Final Environmental Impact Statement for the Buckman Water Diversion Project

**Santa Fe National Forest and Taos Field
Office of the BLM in Santa Fe County,
New Mexico**

Lead Agencies: USDA Forest Service and
USDOI Bureau of Land Management

Figure 2. Vicinity map.

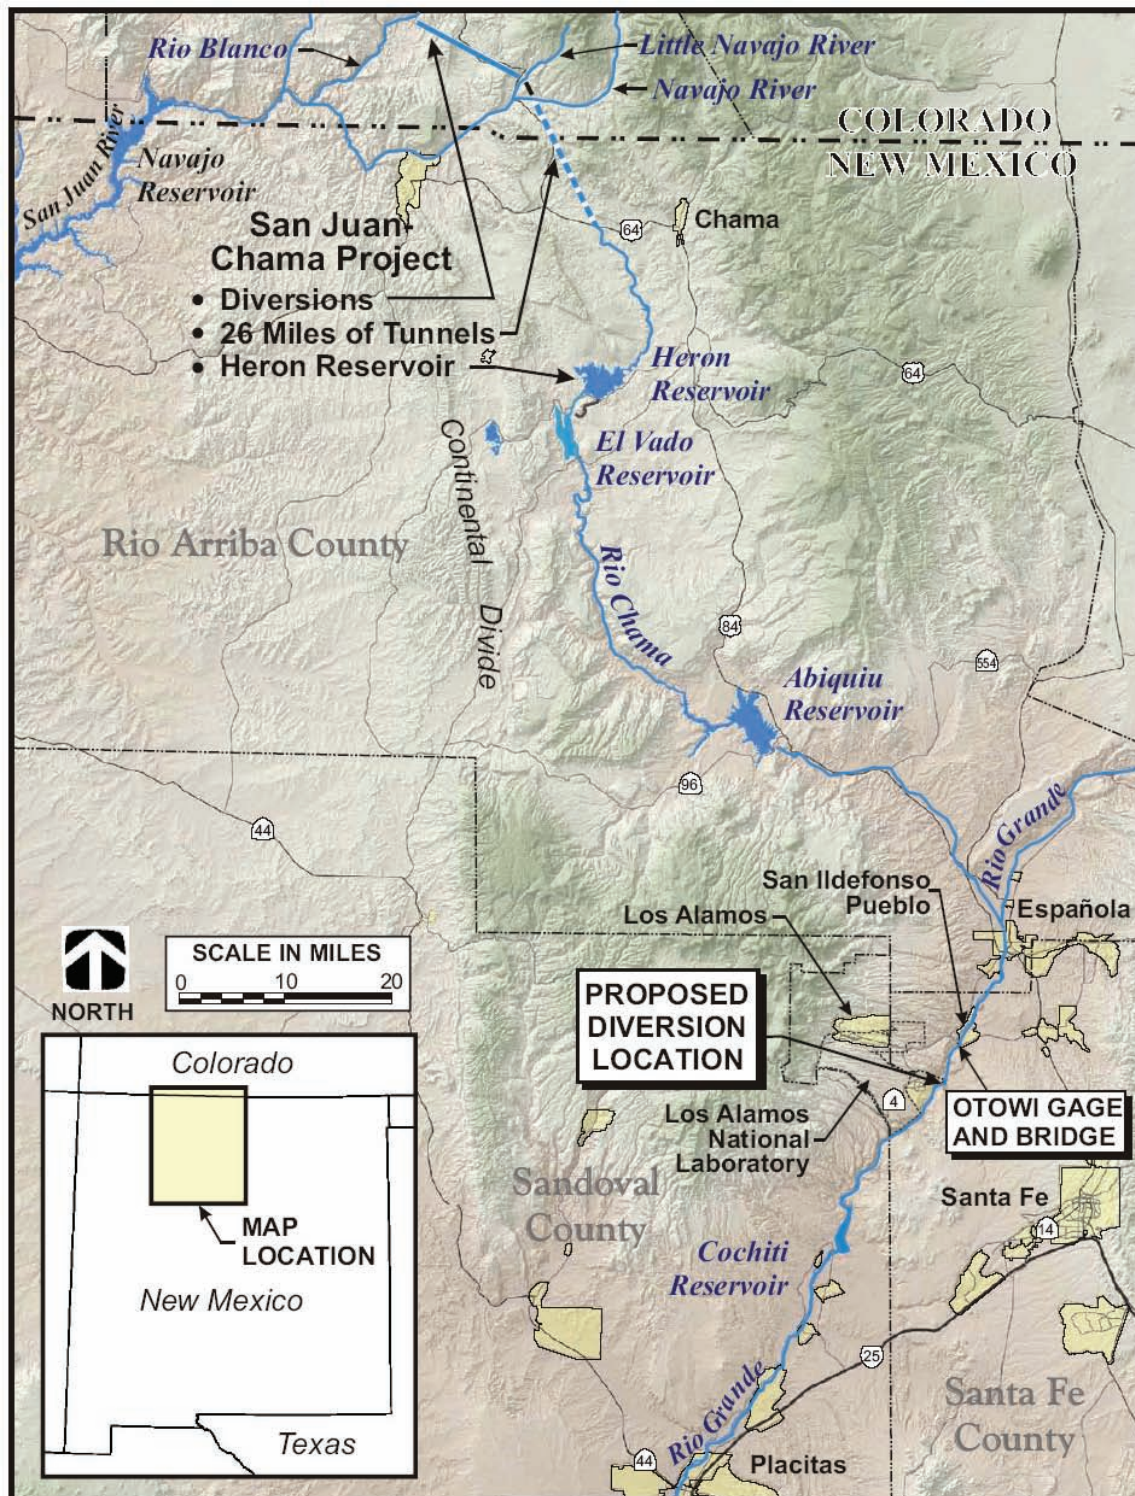
| 8. | At the scoping meeting and on the October 16, 2002 tour, we expressed our concern that LANL is not represented on the maps about the proposal. In fact, we were surprised to see on Figure 2 that the label "Proposed Diversion Location" covers the LANL site. p. 18 draft EIS. | } 5-12 |

- 5-11 Comment noted.
- 5-12 The location of Los Alamos National Laboratory has been added to Figure 1 (Draft EIS, page 8). In addition, Los Alamos National Laboratory has been added to Figure 2 (Draft EIS, page 18).

Figure 3. Location of water diversion, pipeline, and pumping facilities for the Proposed Action.

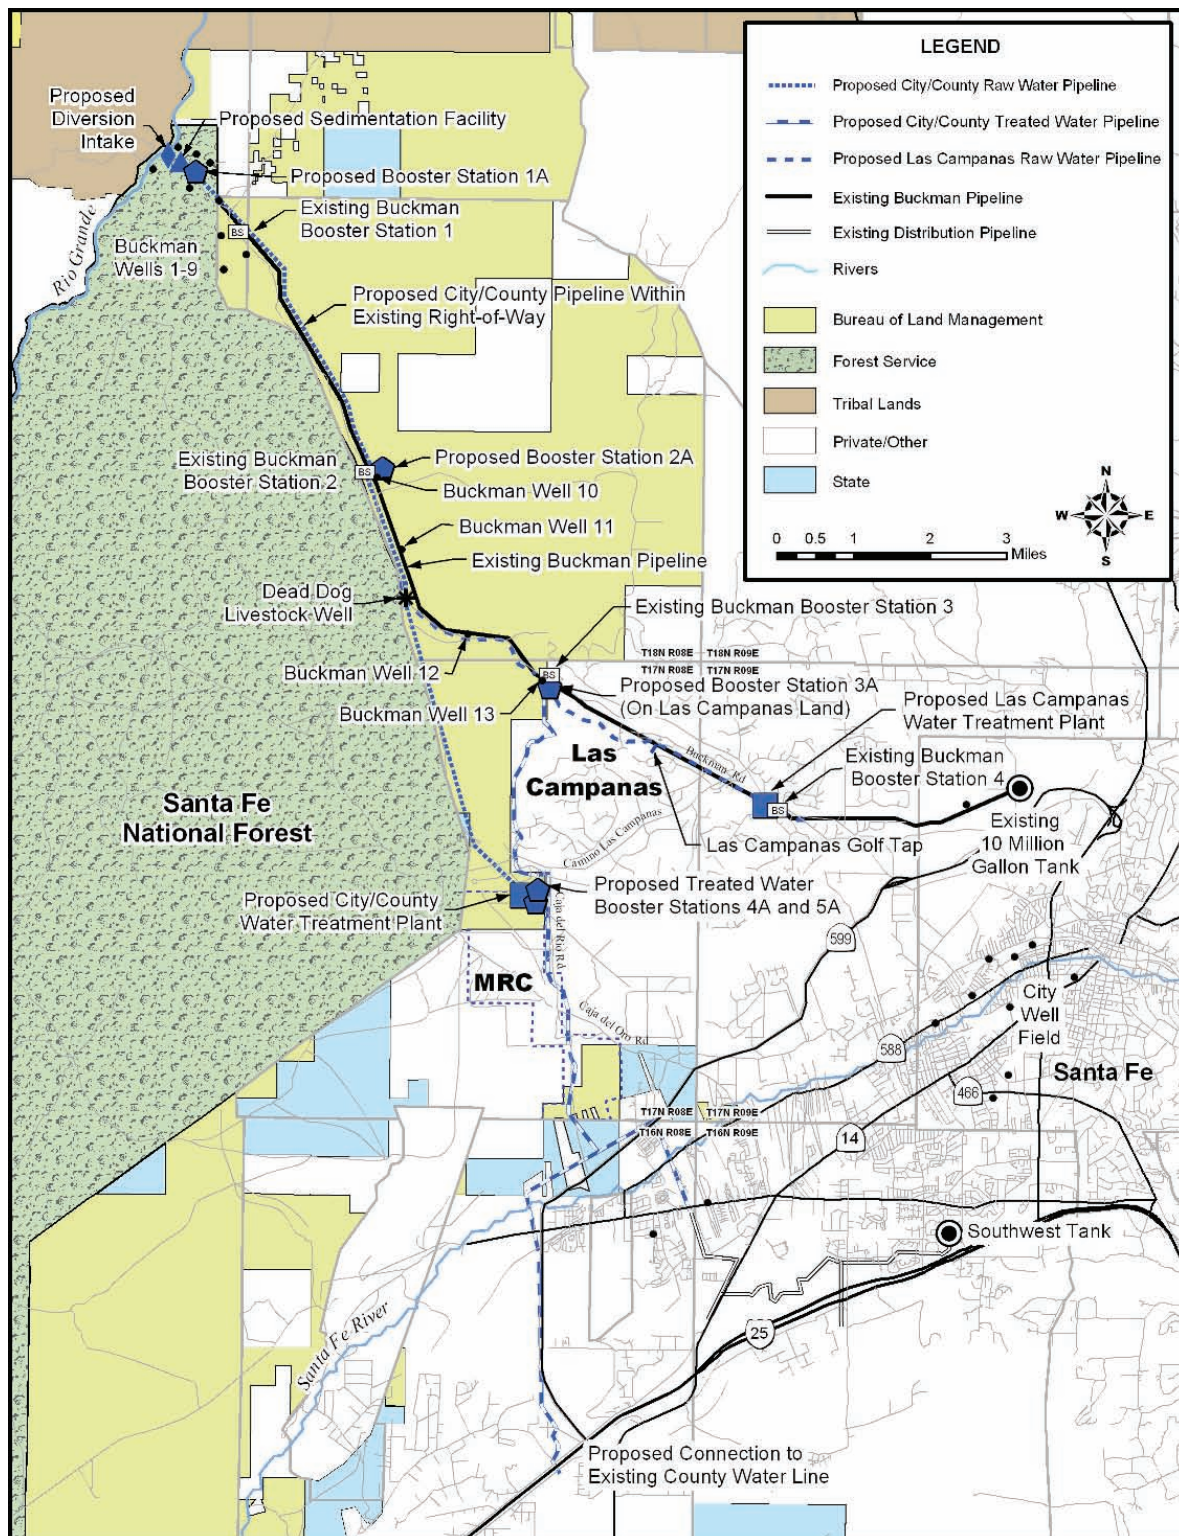
| 16. | We note in Figure 3 that the proposed City/County Treatment Water Pipeline terminates a little south of I-25. The final EIS should explain what it planned for that terminus. p. 20 draft EIS. | } 5-21 |

- 5-21 The text in Figure 3 on page 20 of the Draft EIS shows termination of the proposed City/County treated water pipeline as the proposed connection to the existing County water line. No additional changes will be required for the Final EIS.

Figure 18. Treated Water Pipeline Alternatives.

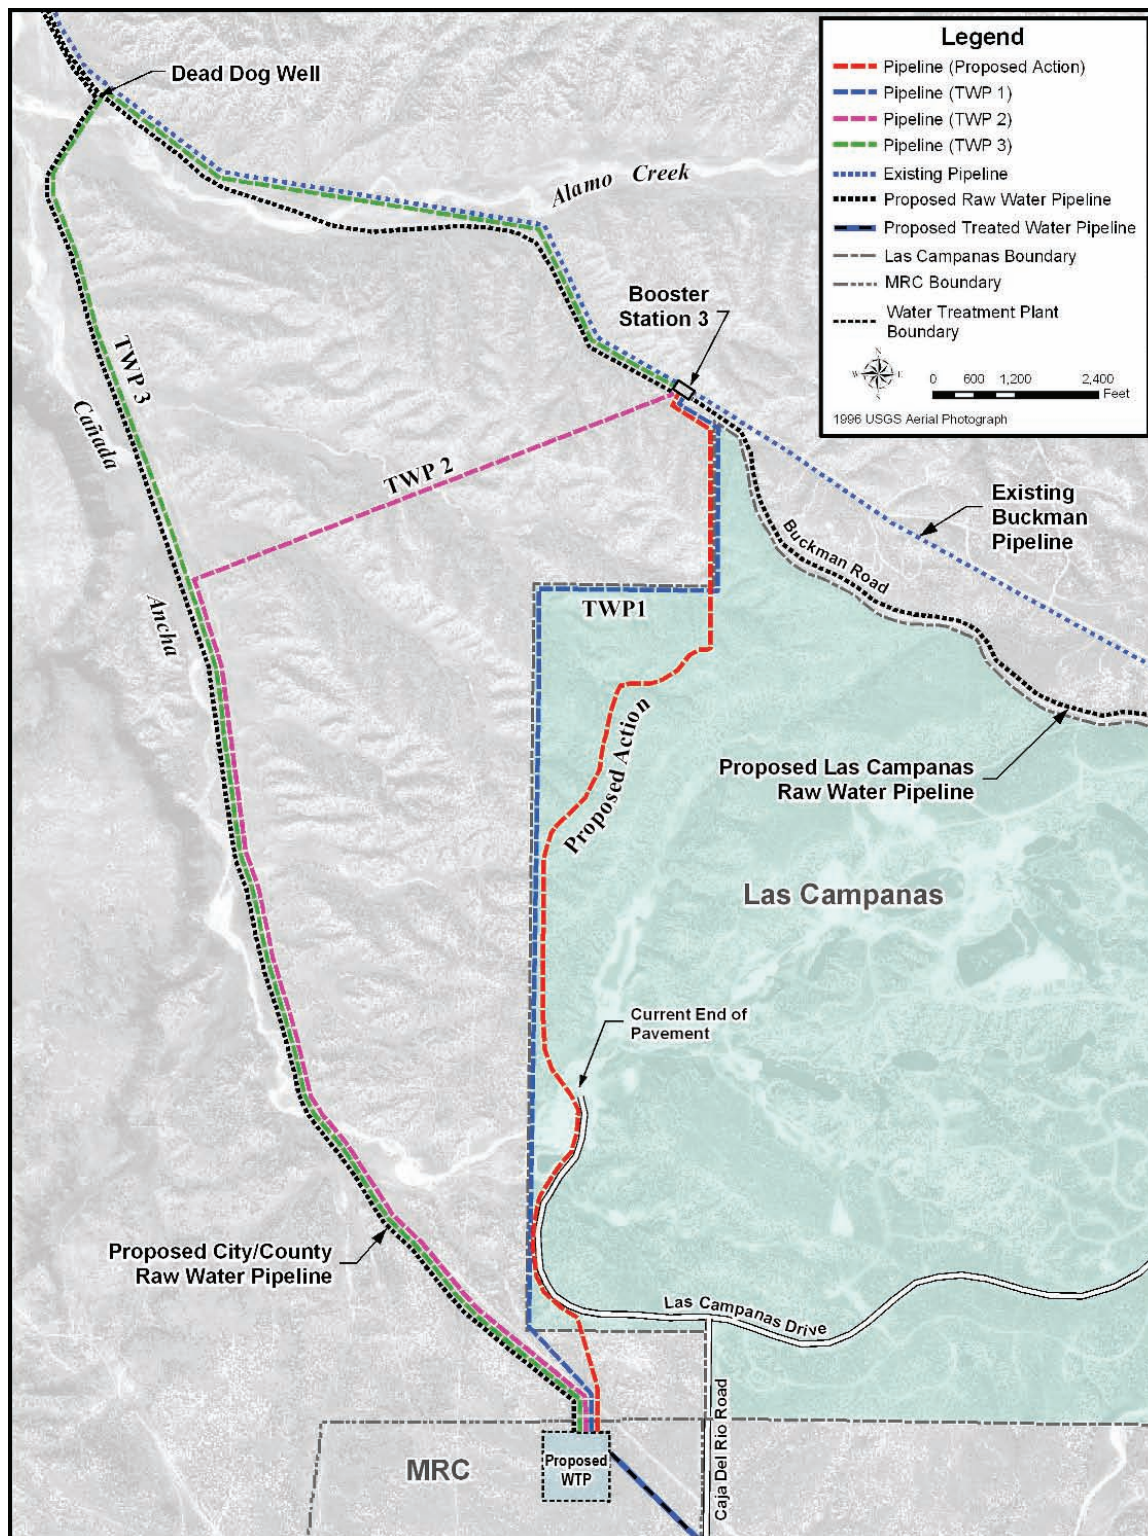
29. We were unable to distinguish the alternatives for the Treated Water Pipeline Alternatives in Figure 18 because the figure was printed in black and white. p. 57 draft EIS. We were also unable to distinguish the alternatives for the power upgrade facilities for the proposed action and	5-34

- 5-34 Figures 18, Treated Water Pipeline Alternatives and Figure 19, Location of Power Upgrade Facilities for Proposed Action and Alternative AGP1 will be printed in color in the Final EIS.

Figure 19. Location of power upgrade facilities for Proposed Action and Alternative AGP1.

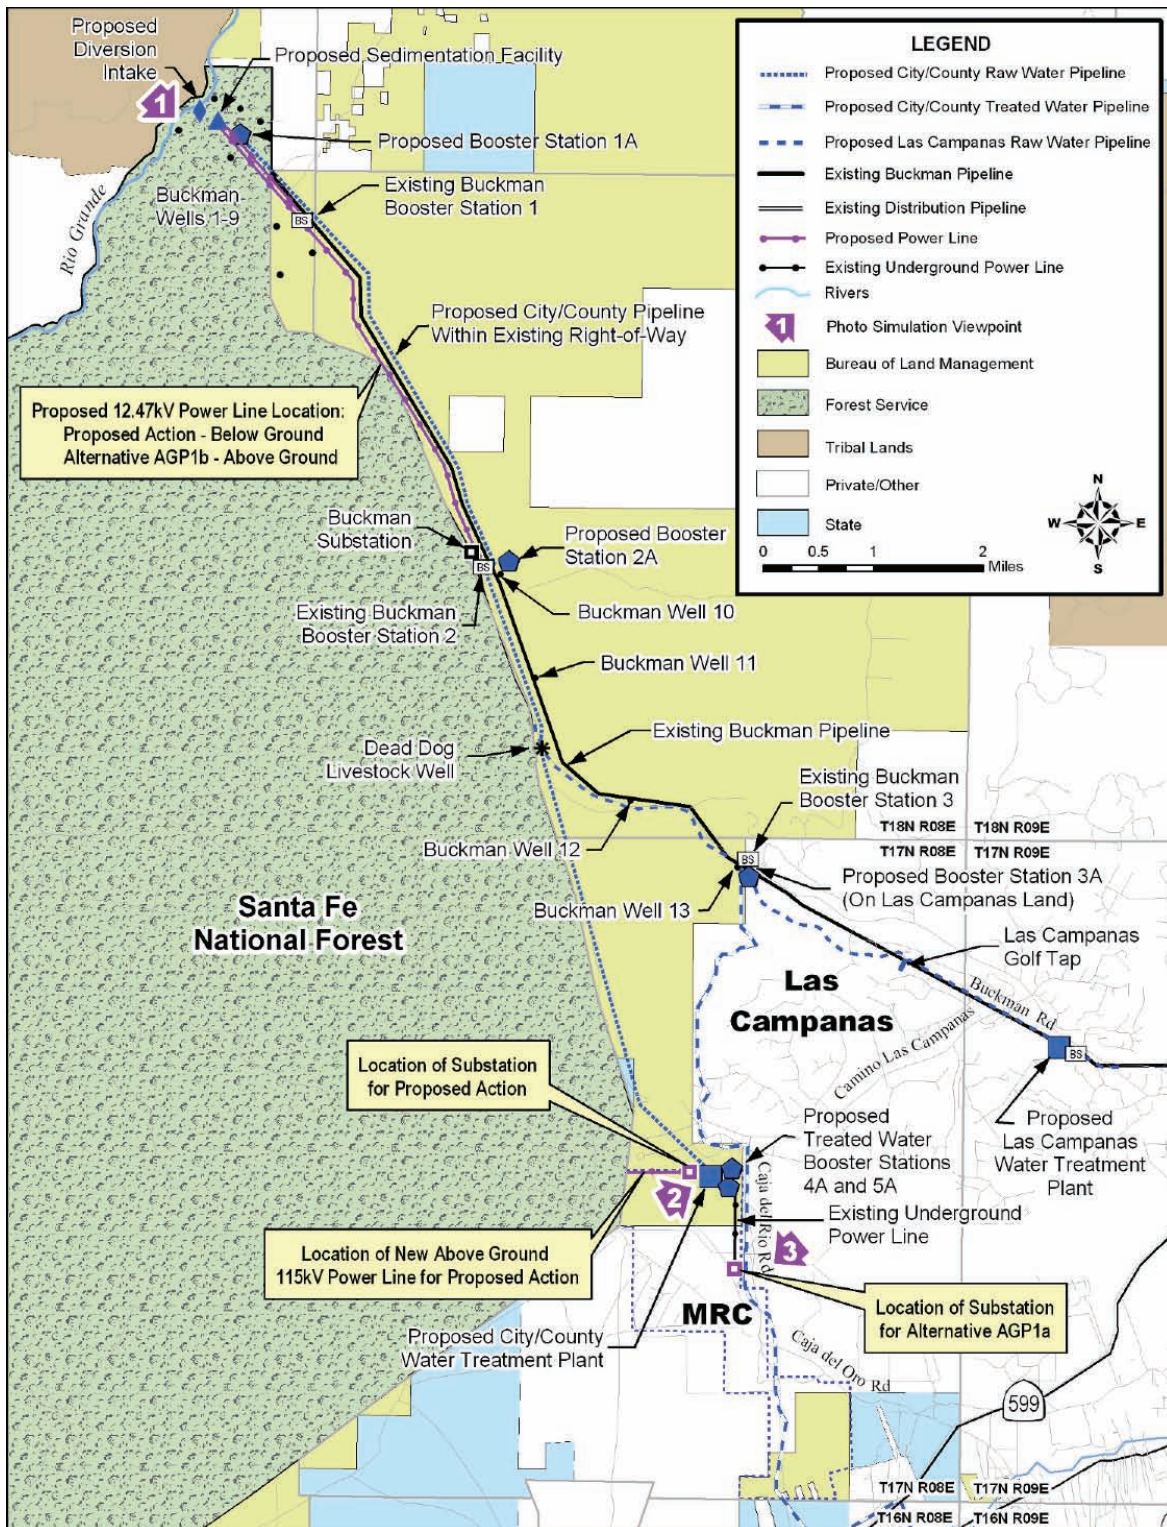
| alternative AGP1 in Figure 19 because it was printed in black and white. p. 60 draft EIS. We strongly urge the FS and BLM to print these figures in color in the final EIS. | } 5-34
